STAFF REPORT
COMMUNITY DEVELOPMENT DEPARTMENT

HEARING DATE: 7/9/2020
 TO: Planning & Zoning Commission
 FROM: Joe Dodson, Associate Planner
 208-884-5533
 SUBJECT: H-2020-0022
 Modern Craftsman at Black Cat

LOCATION: The site is located in the northeast corner of N. Black Cat Rd. and W. Chinden Blvd. (SH 20/26), in the SW ¼ of the SW ¼ of Section 22, Township 4N., Range 1W.

CONCEPT LANDSCAPE PLAN

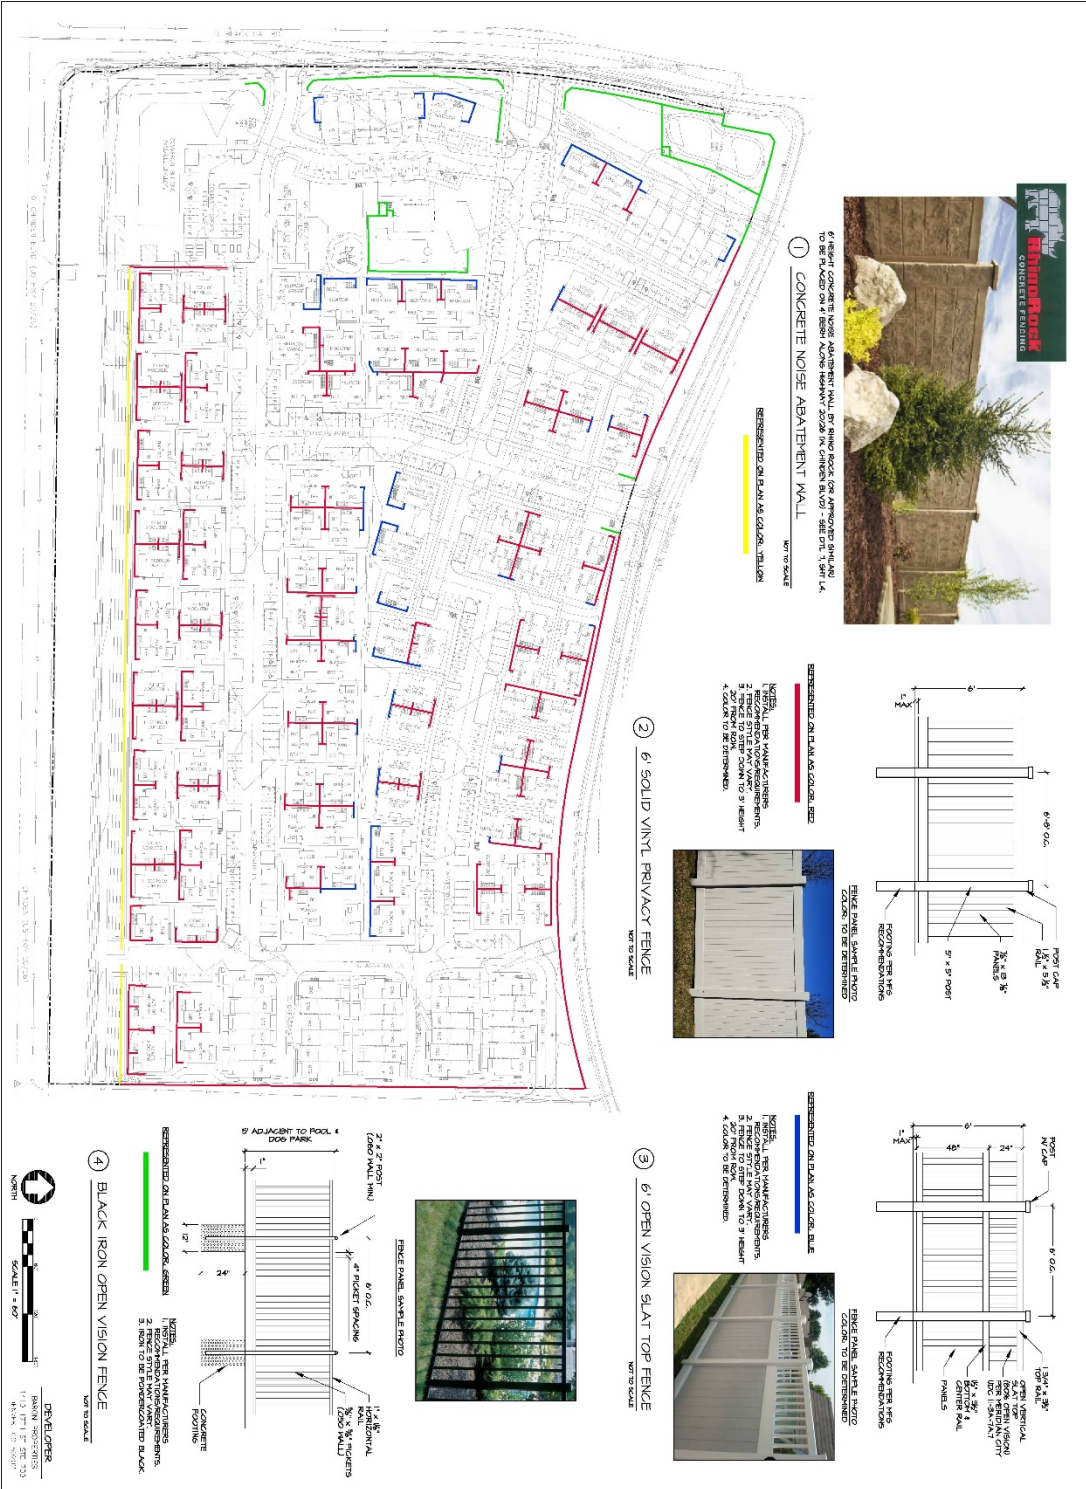
meet the height requirement. Staff notes that this wall is also required to modulate over the course of its length. The submitted landscape plans do not appear to show this modulation so the Applicant will be required to correct the plans prior to final plat submittal.

On the submitted landscape plans, there are no proposed trees or shrubs shown within the required landscape buffer between the commercial lot and SH 20/26. This area of the landscape buffer is also required to be landscaped and Staff is recommending a condition of approval to include landscaping in this area beyond grasses. See Section VII.D for the submitted landscape plans.

Landscaping is required along all pathways (including micro-pathways) in accord with the standards listed in *UDC 11-3B-12C*. The total lineal feet of pathways with the required and proposed number of trees are NOT included in the Landscape Calculations table on the submitted landscape plans, sheet L.4. **The addition of this data in the calculations table will be required as a condition of approval.**

- b. Revise the landscape plans to show the required modulation in the required noise attenuation wall along W. Chinden Blvd. in accord with UDC 11-3H-4D.

- c. Revise the landscape plans and add trees, shrubs, and other vegetative ground cover to the areas of the landscape buffers between the future commercial buildings and Chinden Blvd. and Black Cat Road in accord with UDC 11-3B-7C

- d. Revise the landscape plans to add a 5-foot wide landscape buffer along the northern boundary of the commercial parking area to eliminate conflict of cars backing out into the path of traffic on the private street. The buffer shall be landscaped in accord with UDC 11-3B-8C.

- e. Revise the landscape plans to show trash receptacles and bags for waste disposal throughout the proposed dog park area.
 4. The residential elevations included in Section VII.G, dated February 2020, shall be revised as follows at least 10 days prior to the City Council hearing:
